DOCUMENT CONTROL Stamp		DATE & TIME FOR REVISIONS		EACH SHEET OF MULTI-SHEET DRAWINGS SHALL ALWAYS HAVE THE SAME REVISION LEVEL.	
DRAWING NO. 1001-16 ALUMINUM		DATE 17 SEP 08		REVISION 1	
MATERIAL 6061-T6 ALUMINUM		DRAWN S. EP		APPROVED ALM R. SMITH	
FINISH 1/2\"/>		DATE 17 SEP 08		REVISION 1	
DO NOT SCALE DRAWING		SCALE 1:2		SHEET 1 OF 1

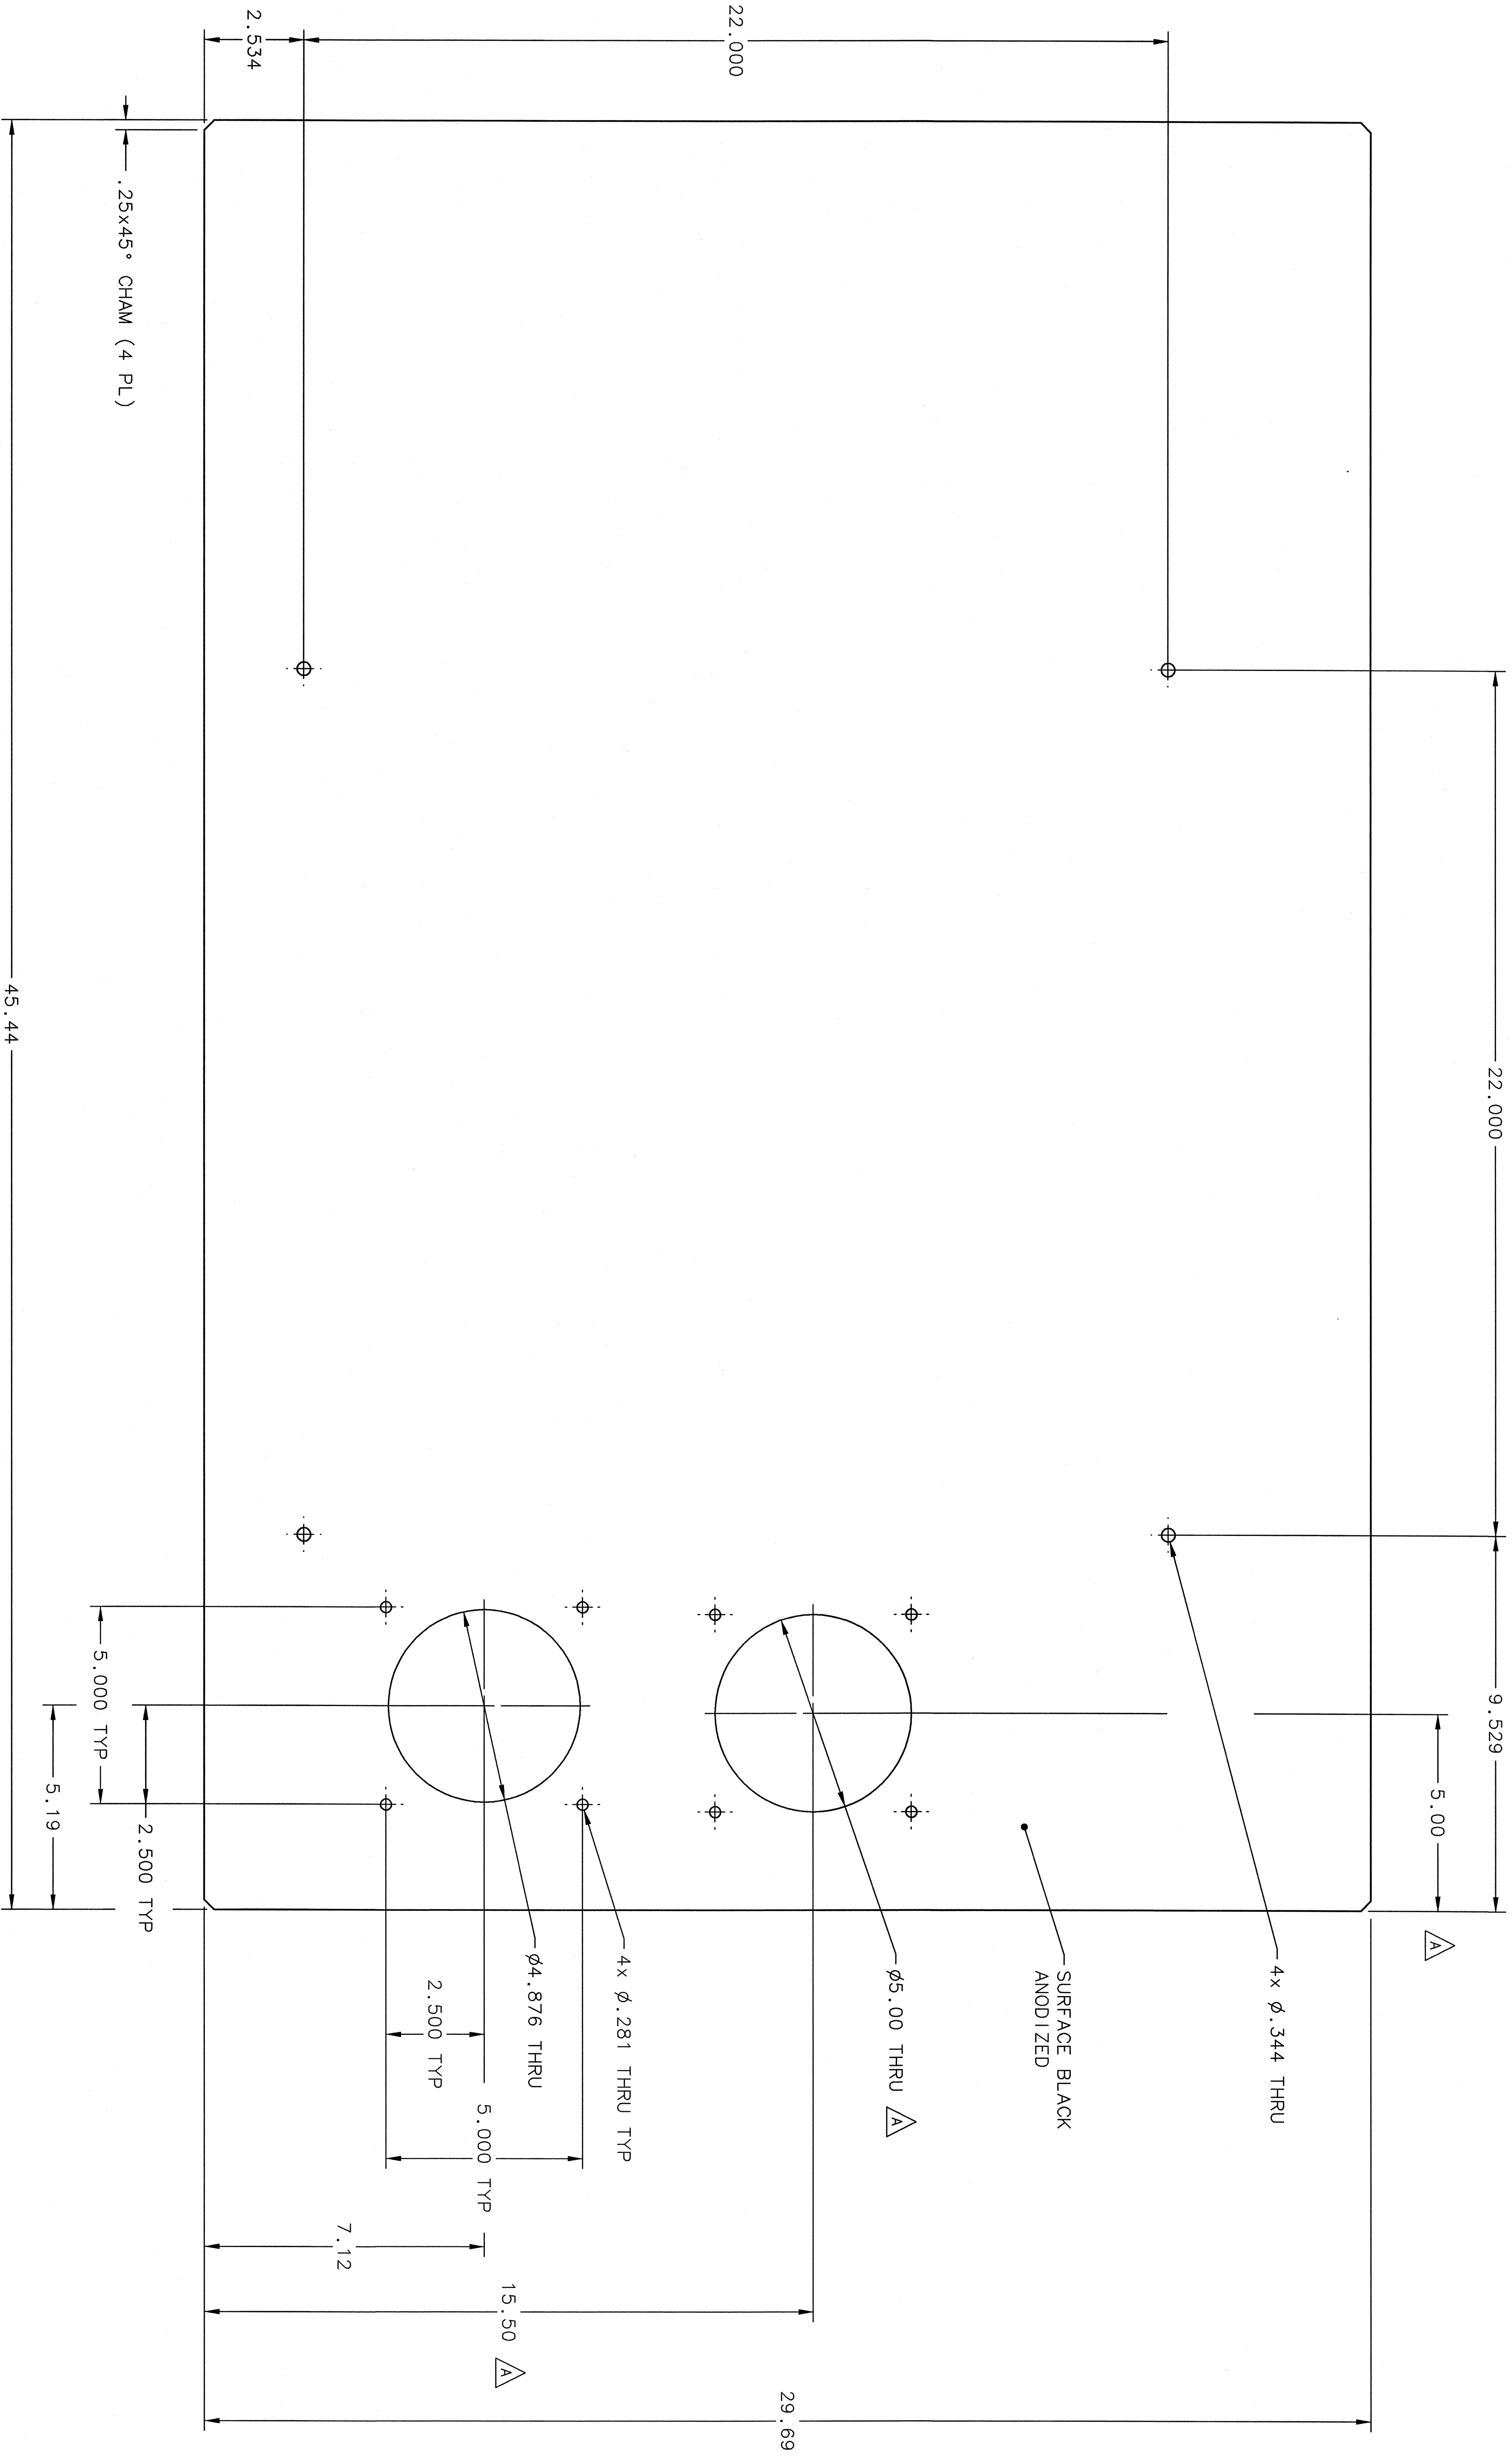
REVISION HISTORY				
ZONE	REV	DESCRIPTION	DATE	APPROVED
1-3E	A	THE FIVE HOLE PATTERN USED TO MOUNT A 5 INCH I.D. DUCT HOSE FLANGE W/MDMT WAS REPEATED DUE TO THE ORIGINAL POSN OF OF THE W/MDMT INTERFERED W/ THE OPTICAL BENCH MAIN SUPPORT. THE DETAIL VIEW OF THE CONNECTOR PANEL CUTOUT WAS REMOVED.	22 SEP 08	SME
			24 SEP 08	AKS
